CITY OF PORTLAND, MAINE
HISTORIC PRESERVATION COMMITTEE

Property Name and Address: Fwi on Carleton Street 46 Carleton St Portland

APPLICATION FOR AMENDMENT TO PERMIT

BUILDING PERMIT REPORT

46 Carlton St.
Portland Me

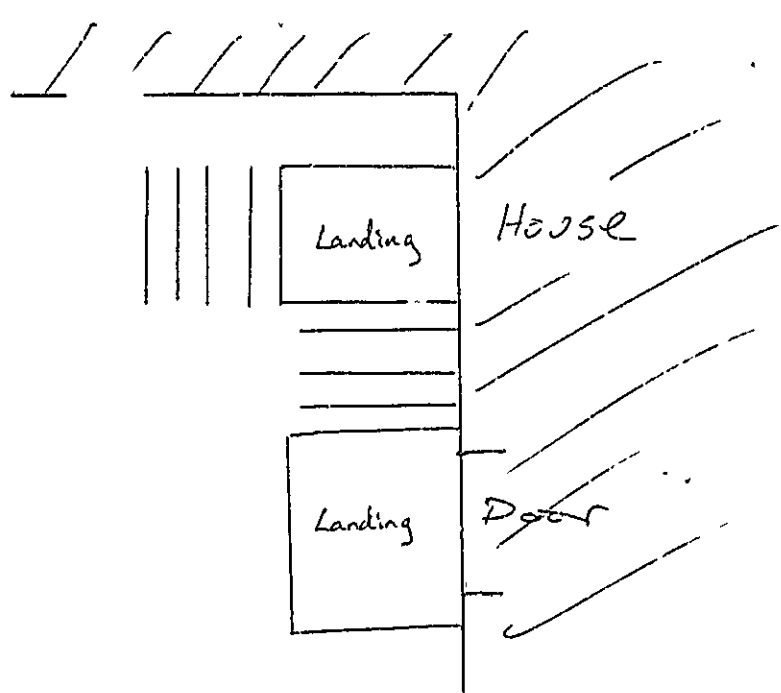
new design - for rebuilt steps

7/12/95 Contractor has installed steps other than submitted and in doing so has created a violation concerning 3'0 clearance w/ electrical service (w/in 1'-0" of service). Steps too close, landing too close. Sven Berglund has reported this date and will advise CMP who will be determining Max. of action. Contractor will apply for an amendment to permit.

7/14/95 CMP inspected meter location and determined that clearance was adequate. If in the future steps are to be rebuilt or changed, owners must bring into compliance.

7/20/95 Project completed as amended.

46 CARLETON ST. 35

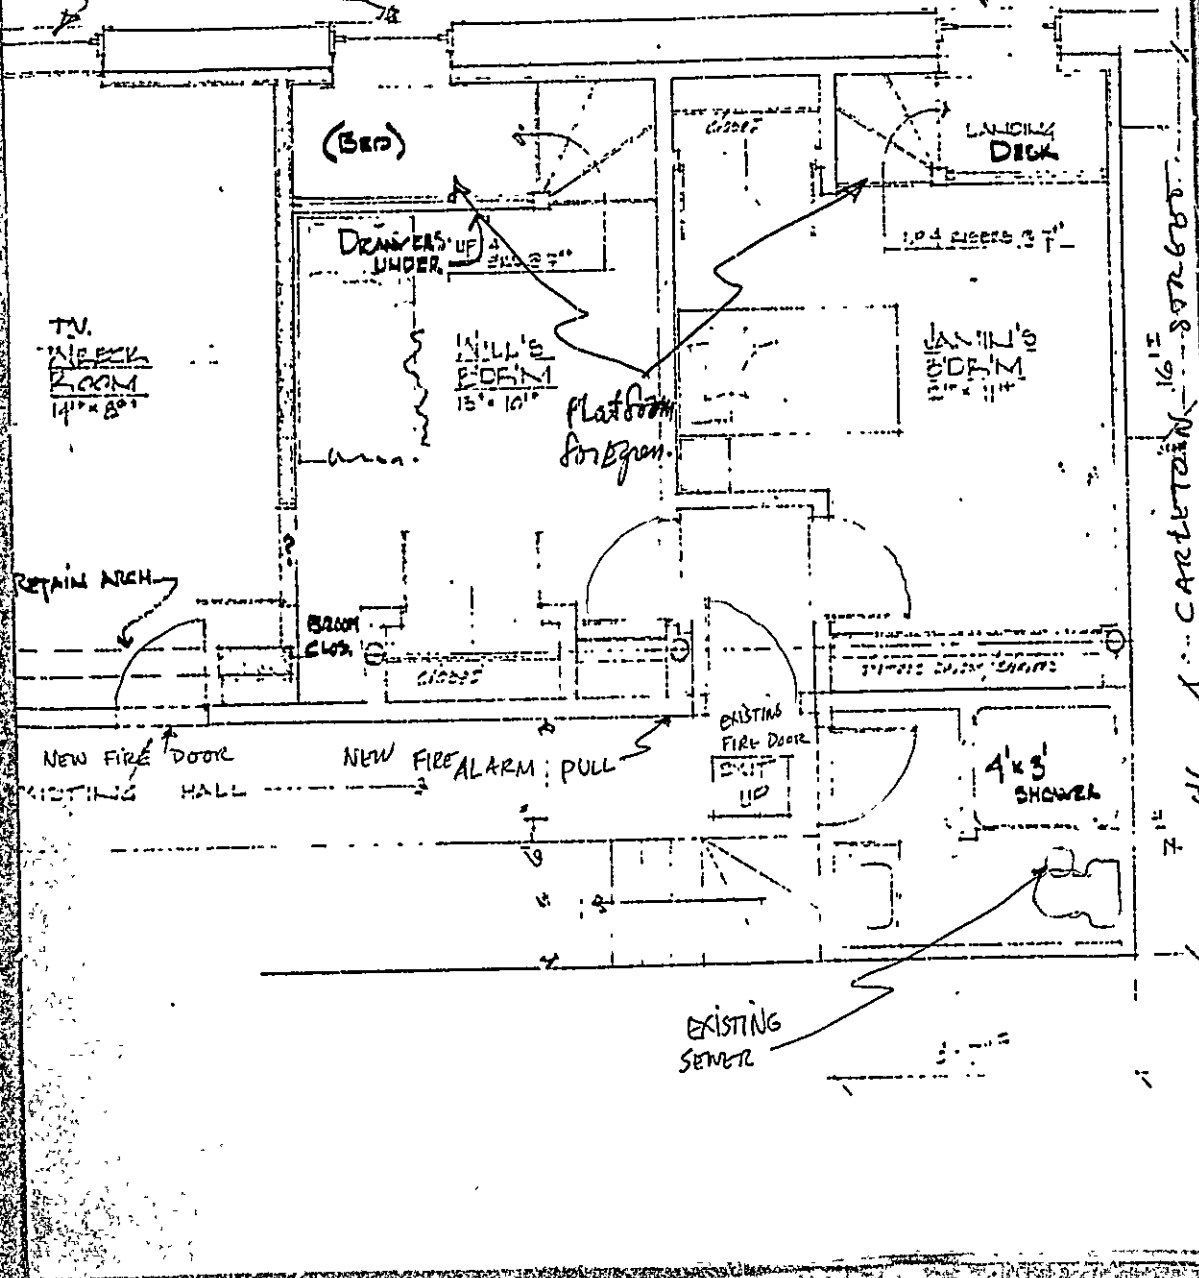
check
SERIAL GM 3240 WINDOW UNITS
NOT CODE - HAVE TO USE CUSTOM UNITS?
